SUBJECT: Document for Publication in the OEQC Bulletin - Final  
Environmental Assessment for Conservation District Use  
Application OA-2788 for Demolition of an Old Single  
Family Residence and Construction of a New Single  
Family Residence

PROPOSED DEMOLITION AND  
CONSTRUCTION OF A SINGLE FAMILY  
RESIDENCE FOR MR. CHARLES DANG  
AT TANTALUS, OAHU.

**PROPOSED DEMOLITION AND CONSTRUCTION OF A NEW  
SINGLE FAMILY RESIDENCE FOR MR. CHARLES DANG AT  
TANTALUS, OAHU**

TMK #: 2-5-16: 2 / Lot Area: 40,825sf / Zone: P-1

**DRAINAGE / EROSION CONTROL PLAN**

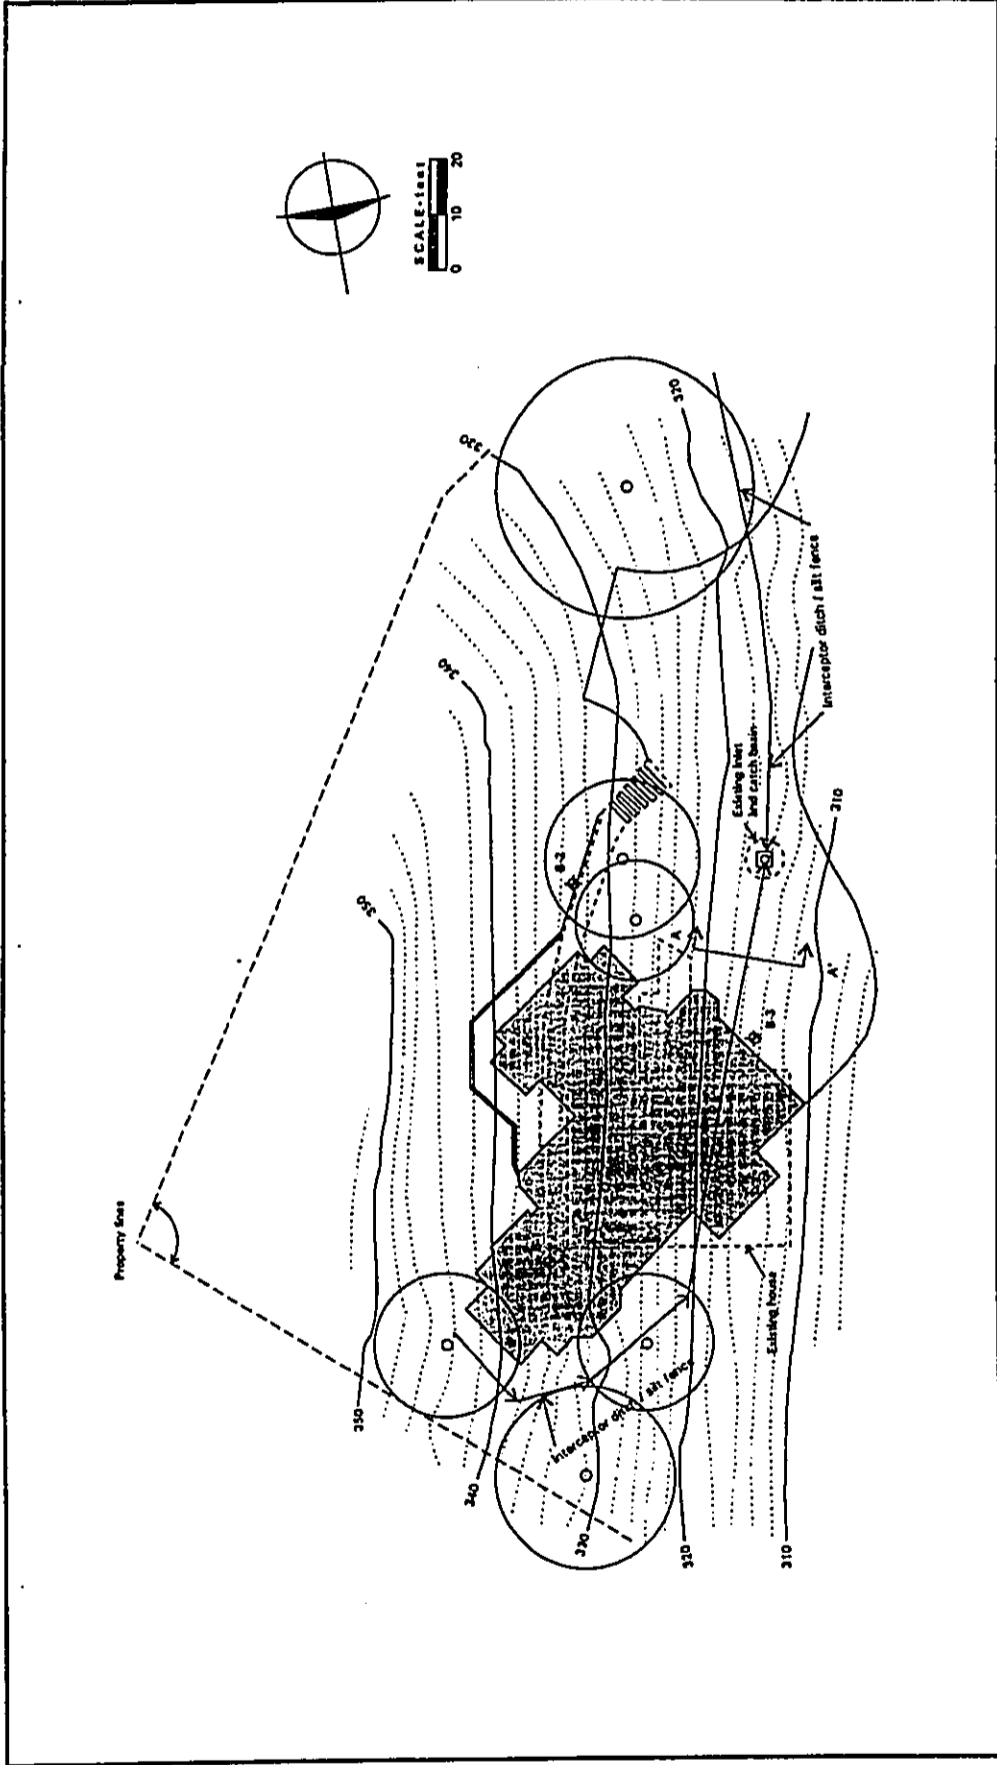
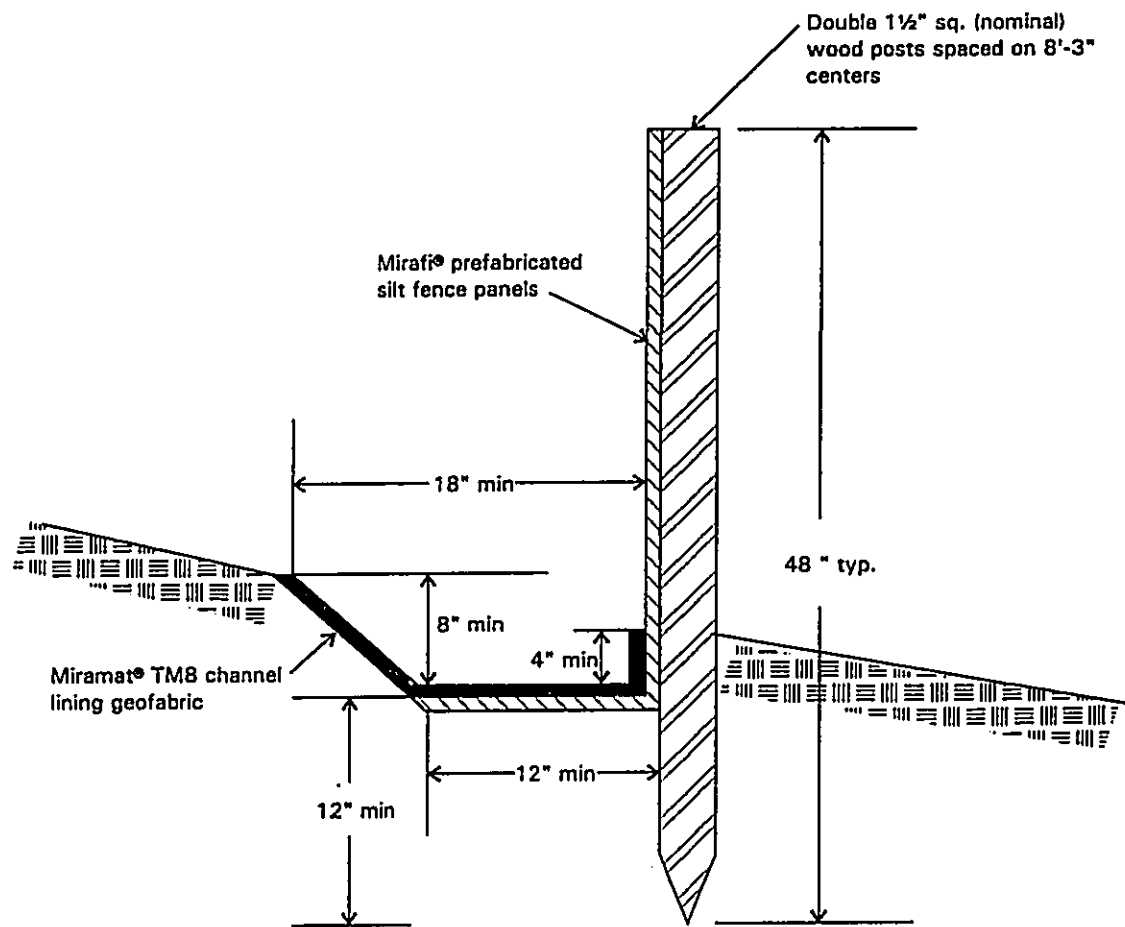
1. Will a temporary barrier be erected prior to demolition of the existing dwelling to prevent soil runoff? If not, will the adjoining property owners be affected?
2. In order to prevent excessive soil runoff, demolition and construction work should be done during the drier months of May through October.
3. The above-described property is within the P-1 Restricted Preservation District. Permitted uses and structures in the Conservation District are not governed by the City's Land Use Ordinance.

The draft Environmental Assessment (EA) does not explain how potential construction impacts such as noise and storm water runoff will be controlled. Page 3 of the draft EA indicates that an additional 1,000 square feet will be added to the current structure's footprint. The proposed project will also involve the removal of approximately 750 cubic yards of soil to accommodate new foundations for the new single-family home. Given the property's steep topography and the area's high annual rainfall, the final EA should describe the site's existing soil conditions, drainage conditions, its susceptibility to erosion, and how potential erosion and drainage impacts will be mitigated.

Item 1 - A temporary siltation barrier and interceptor ditch system will be constructed in accordance with the attached Erosion / Drainage Control Plan and Typical Drainage/Erosion Control Details to prevent soil runoff prior to demolition of the existing structure. Strict implementation and maintenance of this plan will allow construction before May.

The only part of the property within which the soils will be exposed during construction is limited to the building footprint, immediately adjacent upslope areas, and the proposed driveway improvement zone, extending less than 100 feet away from the house envelope, within a previously graded area. At these locations, the soils will be exposed during demolition, clearing, grading and operations. Drainage and erosion control during construction will be provided by means of the devices shown on the attached Drainage/Erosion Control Plan and Typical Drainage/Erosion Control Details.
